4. Additional investigations and clarifications to the Environmental Assessment

4.1 Additional investigations

4.2 Clarifications to the Environmental Assessment

Figure 4-1 Proposed construction access routes to the construction compound at the new Schofields Station and western track works

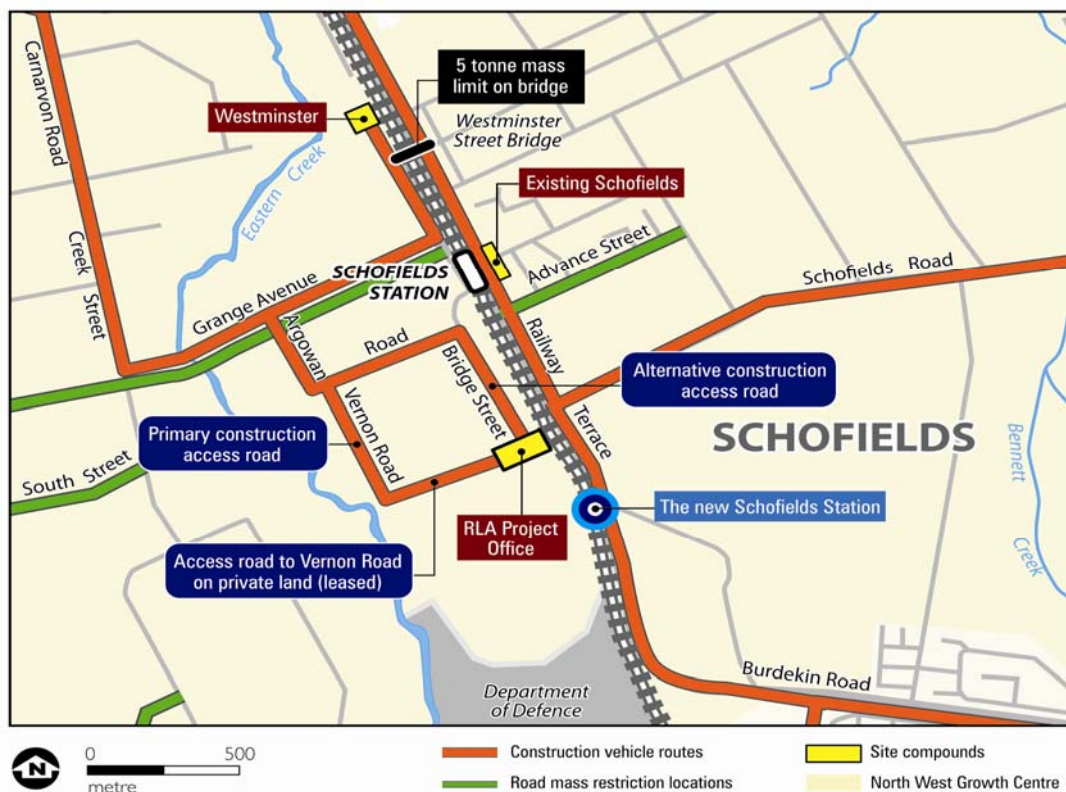
There was an inconsistency in the proposed construction access route to the new Schofields Station between Section 8.2 and Chapter 10 of the Environmental Assessment. As described in Section 3.2.3, the preferred construction access route would be via Vernon Road and a haul route constructed on private property. Bridge Street would be used as an alternative construction access route to the new Schofields Station construction compound.

As discussed in Section 3.2.3, all construction vehicles would initially need to use Bridge Street to enable site setup and for constructing the access haulage roads (linking the site to Vernon Road). Once established, the majority of vehicles (light and heavy) would enter the site via the haul road and Vernon Road. Access via Bridge Street would be maintained mainly for light vehicles (as required) and as a backup route to ensure access is maintained to the Project site. During the demobilisation phase of the project (the final 2-3 months prior to handover in 2011), access through Vernon Road would be removed and traffic directed through Bridge Street. The proposed construction access route to the construction compound at the relocated Schofields Station is shown in Figure 4-1, while construction access routes for the wider Project area are shown in Figure 4-2.

Figure 4-4 Cycle paths proposed to be developed by the Strategies and Land Release Branch
 Source: Growth Centres Commission (2007) Riverstone and Alex Avenue - Transport and Access Study, October 2007

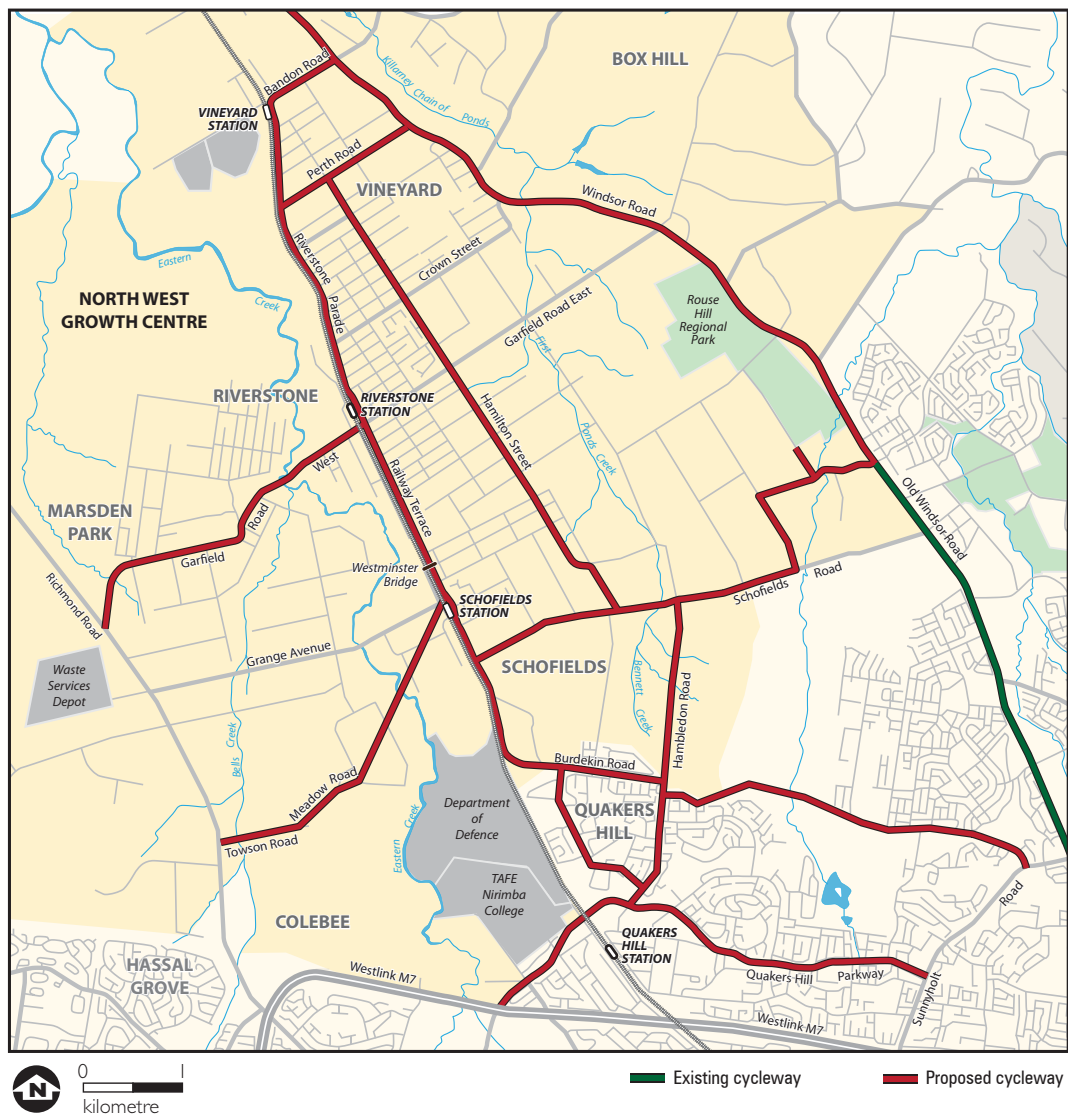
Some community members sought clarification on the cyclist facilities that would be provided as part of the Project. In summary, a shared pedestrian/cyclist user path is proposed between the existing and new Schofields stations. The provision of bike racks and space for bike lockers at the Schofields, Riverstone and Vineyard stations would be determined during detailed design in consultation with the MoT. The current design for Schofields Station indicates that approximately 40 bike racks would be provided at the new Schofields Station, as well as concrete padmounts to allow for bike lockers to be installed in the future.

Additional cycle paths are not proposed as part of this Project. As described in Section 3.1.3 of the Environmental Assessment, the development of additional cycleway infrastructure alongside the rail corridor could be provided by developers in the future as development of the NWGC continues (GCC 2008c). An indicative plan for additional cycle paths that the Strategies and Land Release Branch proposes to develop within the NWGC is shown in Figure 4-4.

Figure 4-5a Revised mapping of vegetation communities relative to the area impacted by the Project
 Note: Project detail shown is indicative only, subject to detailed design.

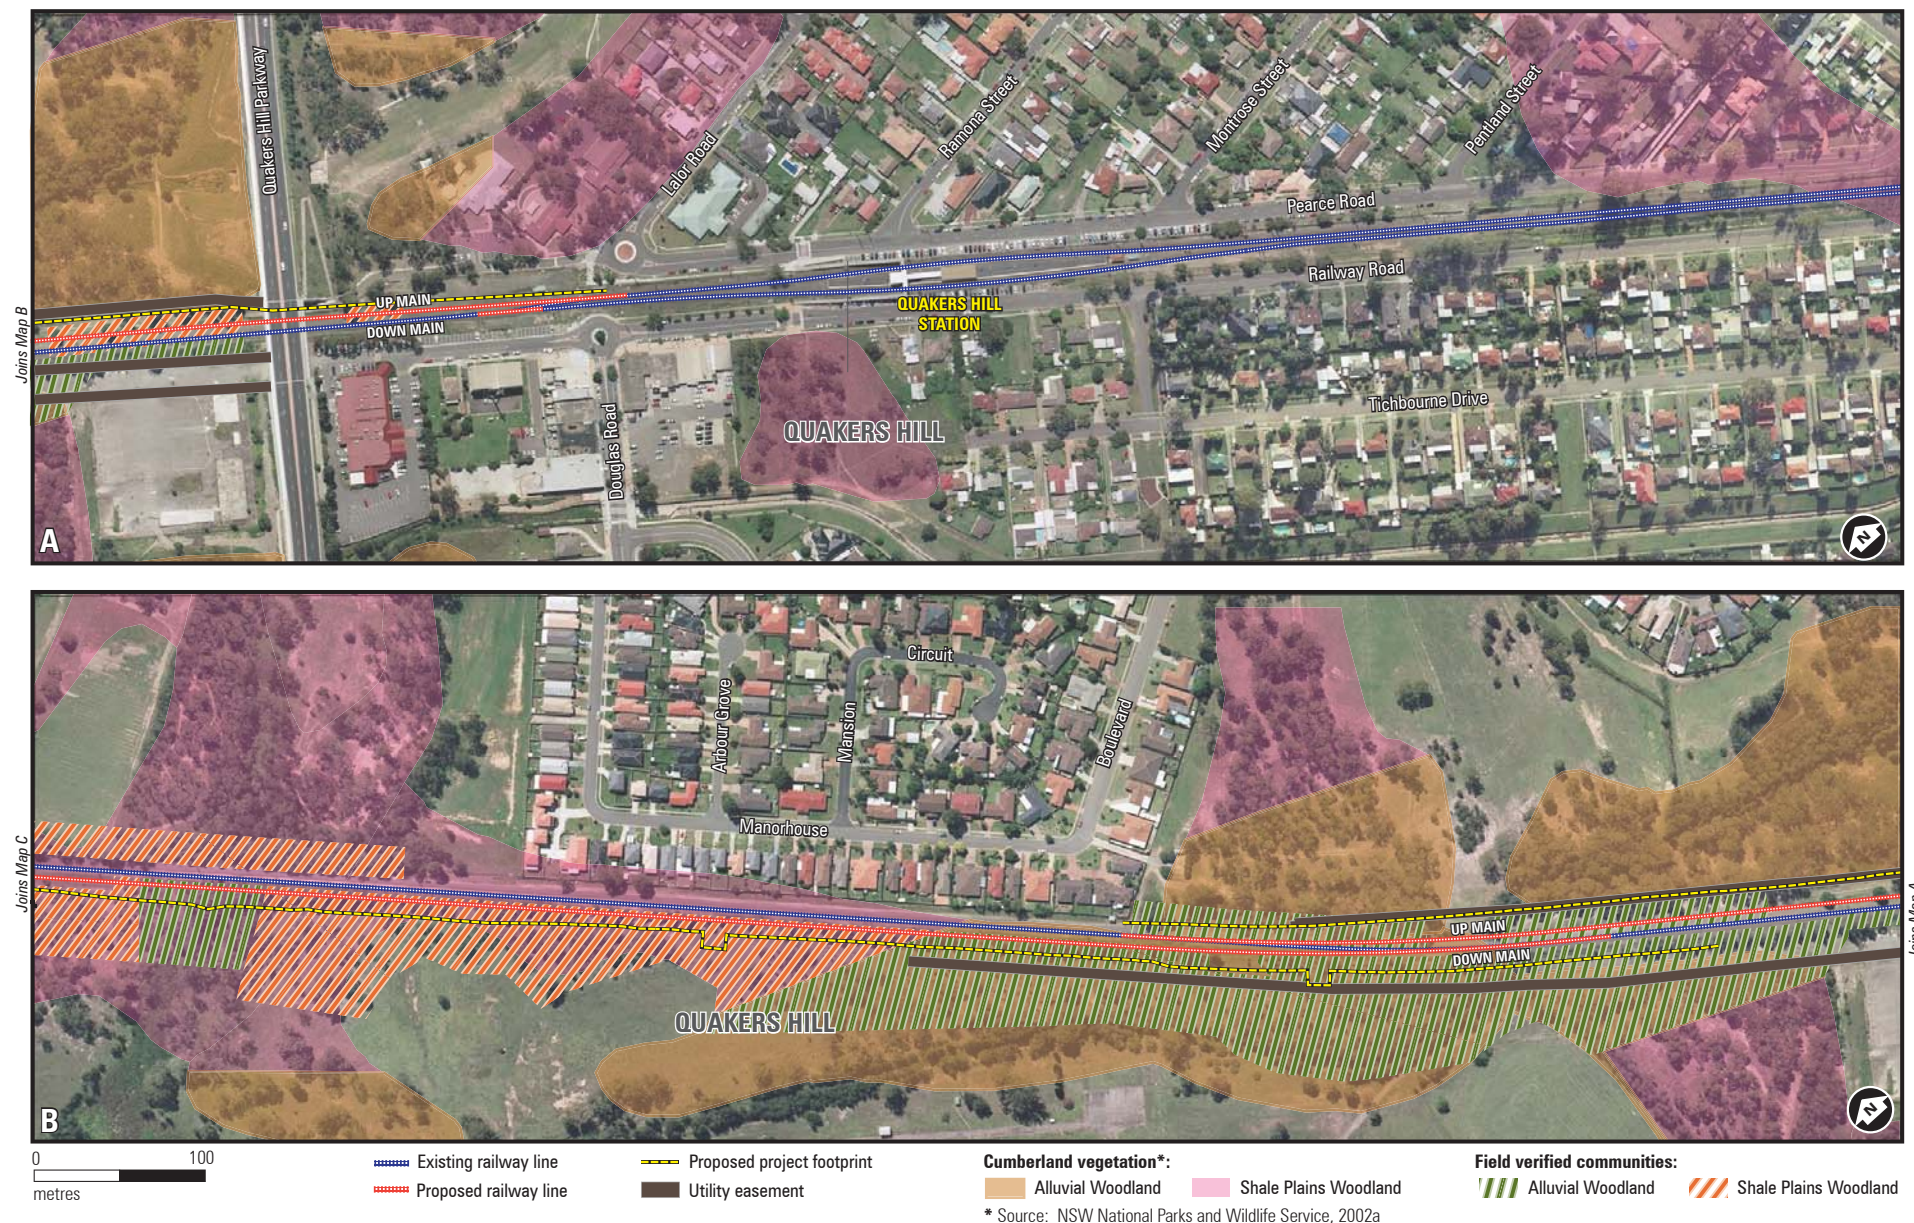
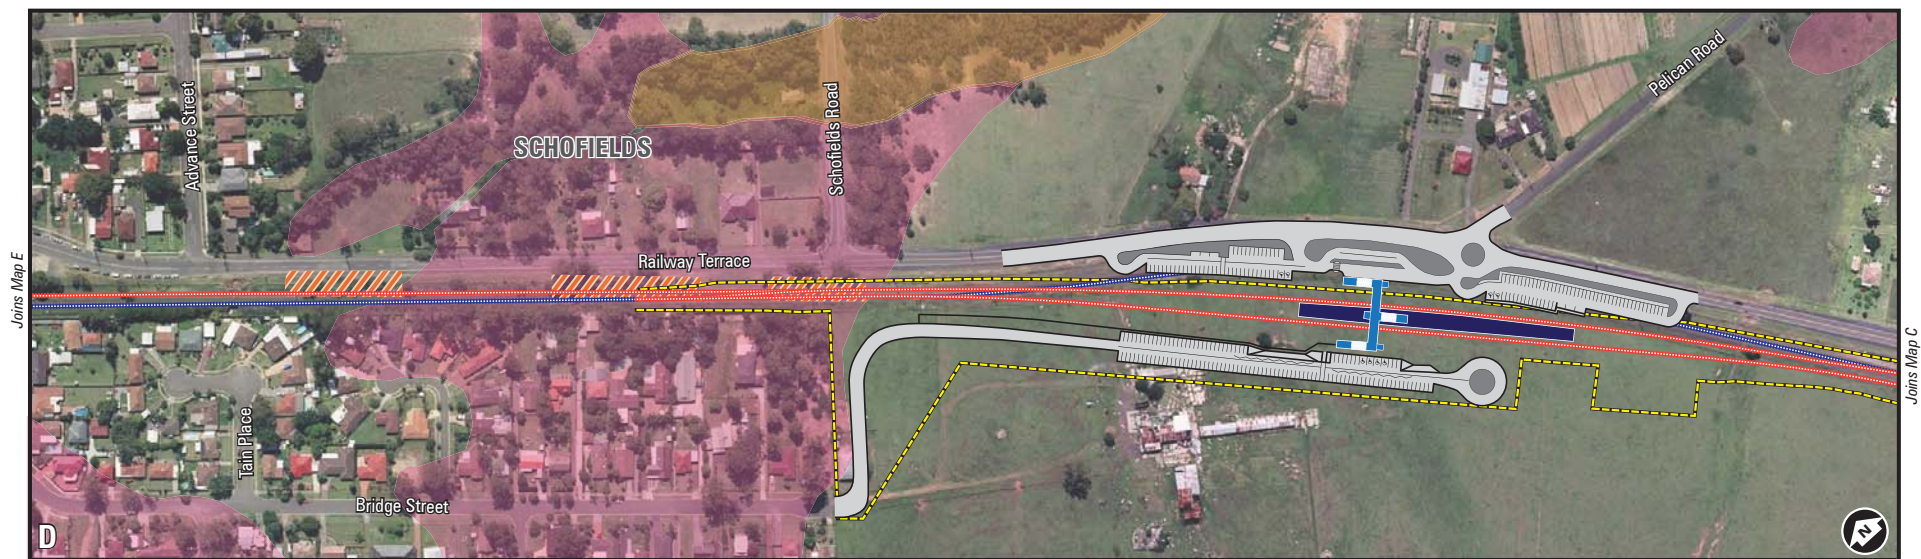
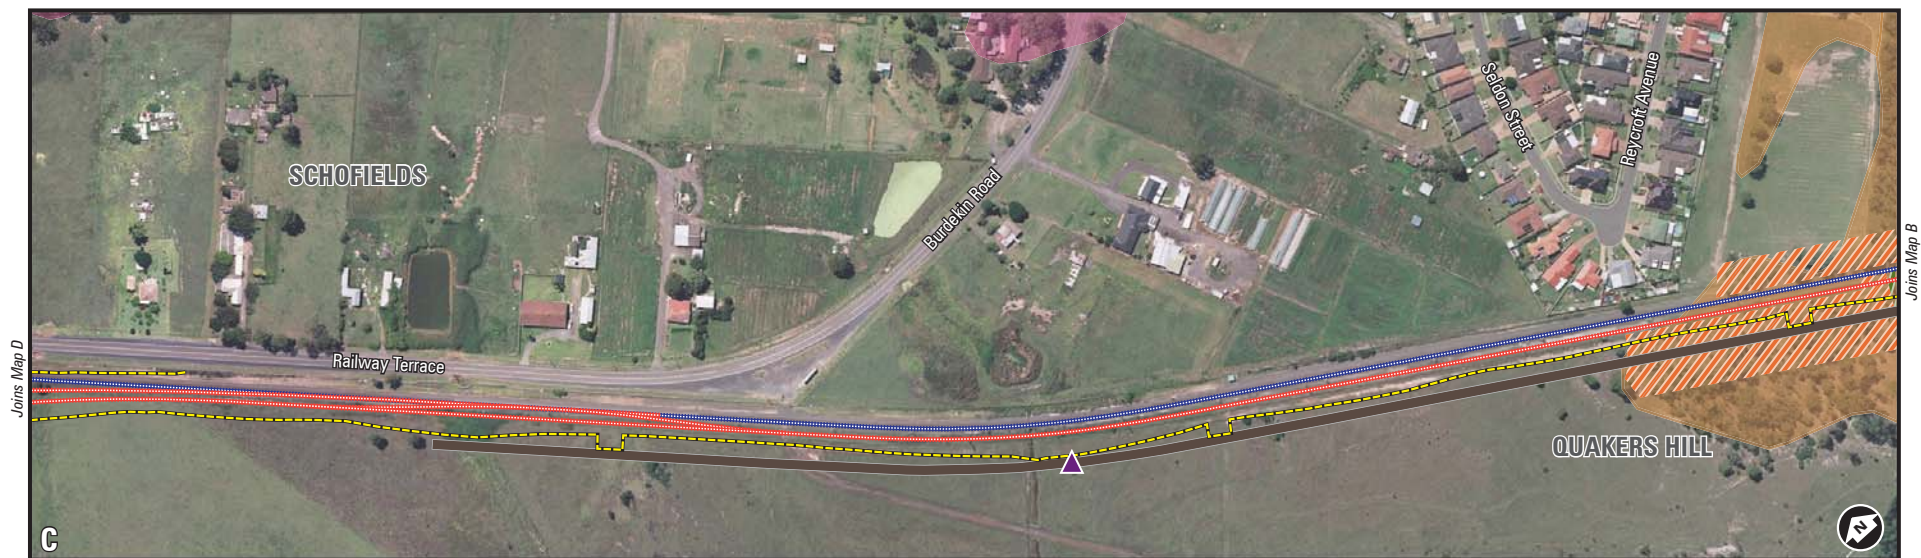
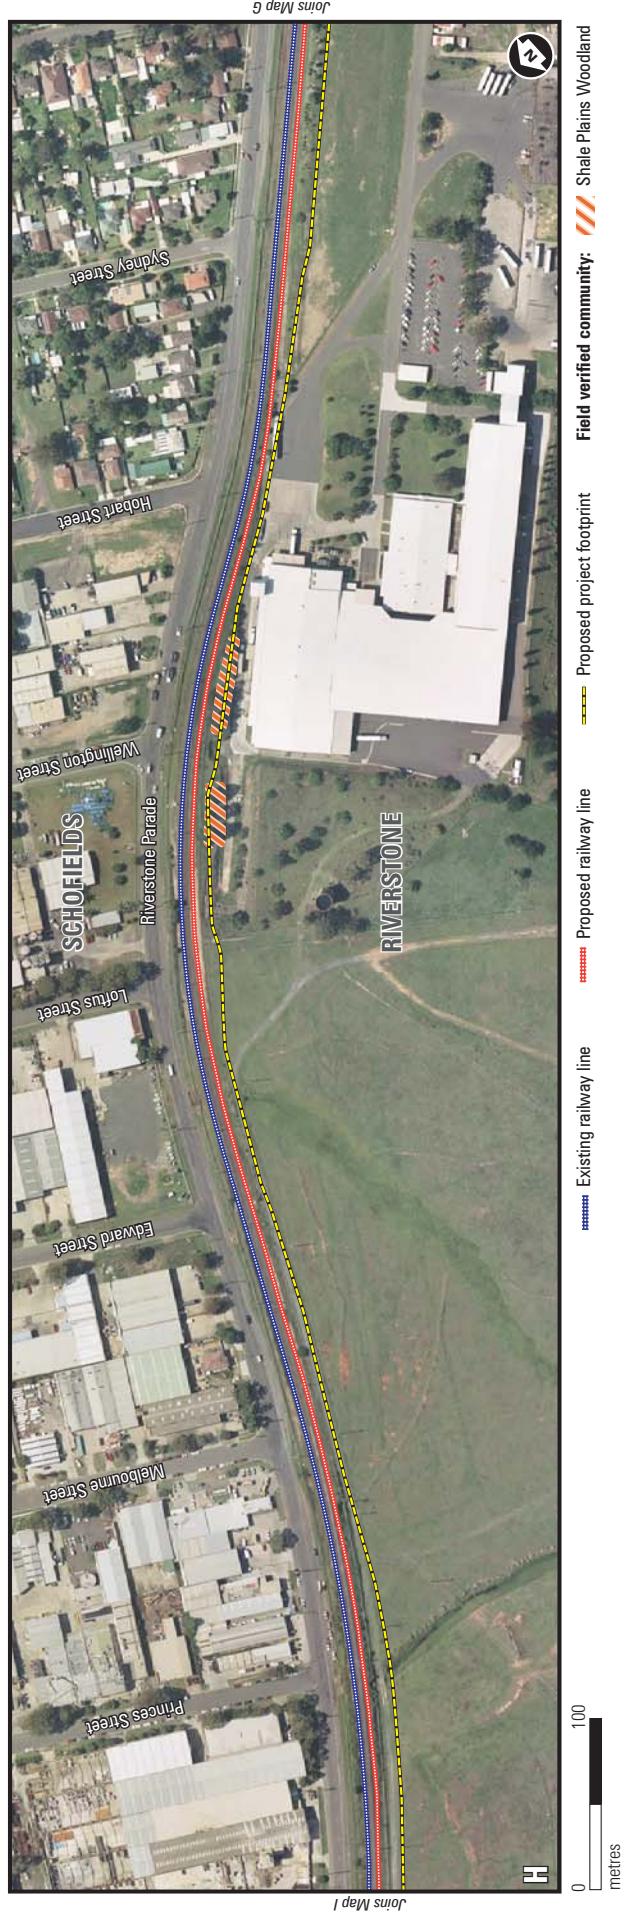
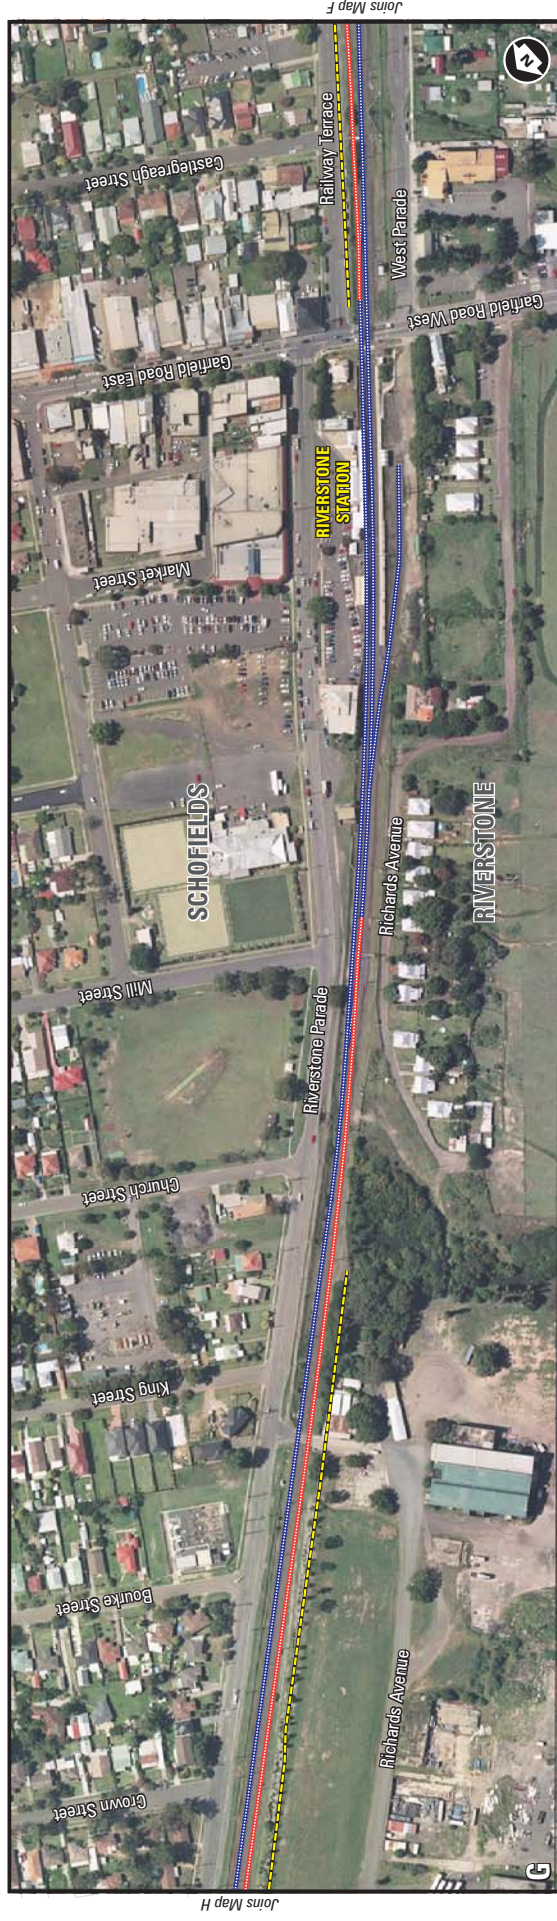
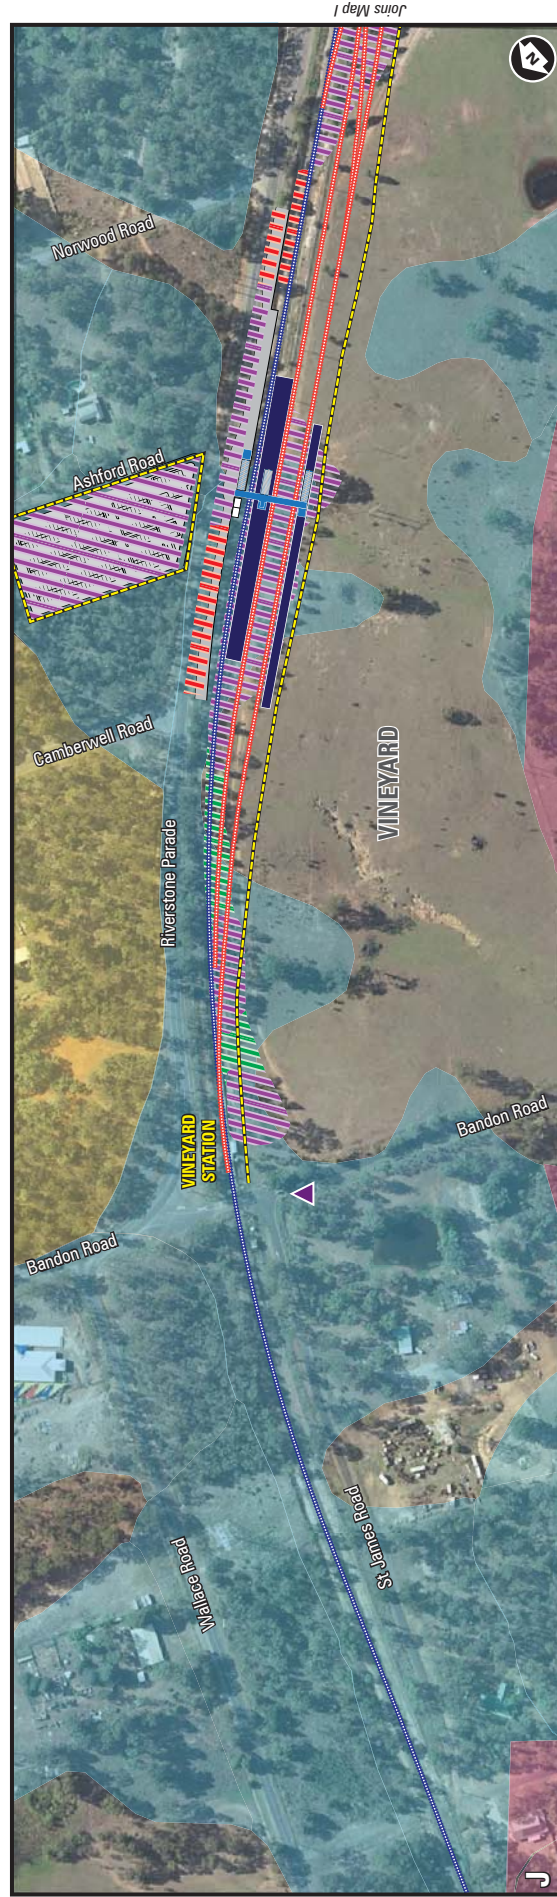
DECC noted in their submission that the vegetation mapping illustrated in the Environmental Assessment (Figures 3-19 and 8-11) and Biodiversity Assessment (Figure 4-1 of Technical Paper 5) did not include Endangered ecological communities mapped as polygon class TXU (canopy cover less than 10% - Urban Areas) in the *Native Vegetation of the Cumberland Plain, Western Sydney* (National Parks and Wildlife Service 2002a).

It is acknowledged that, while the vegetation mapping presented in the Environmental Assessment and associated Technical Paper were based on the *Native Vegetation of the Cumberland Plain, Western Sydney* (National Parks and Wildlife Service 2002a), the mapping did not include Endangered ecological communities mapped as polygon class TXU (canopy cover less than 10% - Urban Areas). As such, additional vegetation mapping has been undertaken for the Project to include this vegetation community. The revised vegetation maps for the Project are shown in Figure 4-5.

While Endangered ecological communities mapped as polygon class TXU (canopy cover less than 10% - Urban Areas) were not included in the vegetation mapping included in the Environmental Assessment or the Biodiversity Assessment, all vegetation within the Project footprint was field verified during the preparation of the Biodiversity Assessment. As such, the addition of the Endangered ecological communities mapped as polygon class TXU into the vegetation maps will not change the conclusions reached in the Environmental Assessment.
